Lloyd's Register of Shipping,

I duly received your letter of the 13th instant, with plan, in triplicate, advised therein of shafting proposed for Messrs. Aalborg Vaerft's Yard No.64.

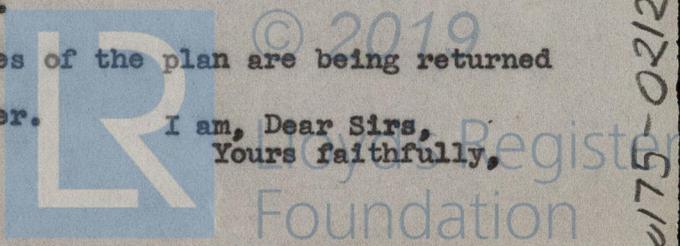
The plan has been examined and I have to inform you that with 2 SCSA oil engines for main propelling purposes, having 6 cylinders, diameter 500 mm., stroke 900 mm., revolutions per minute 164, maximum pressure in cylinders 49 Kgs per sq. cm., B.H.P. 1850, GD^2 of balance weights 4600 Kgm^2 , GD^2 of turning wheel 1150 Kgm^2 , diameter of propeller 3225 mm., and screw shaft with continuous liner, the following sizes of shafting will be approved, viz:-

Intermediate..... 235 mm. diameter.
Screw..... 270 mm. diameter body reduced to
255 mm. diameter at forward end.

The plan showing details of the intermediate and screw shafting will also be approved for a vessel intended to have the notation "Strengthened for Navigation in Ice", it being concluded that the material of the propeller will be in accordance with the requirements of Section 40, Clause 6, of the Rules for Steel Ships.
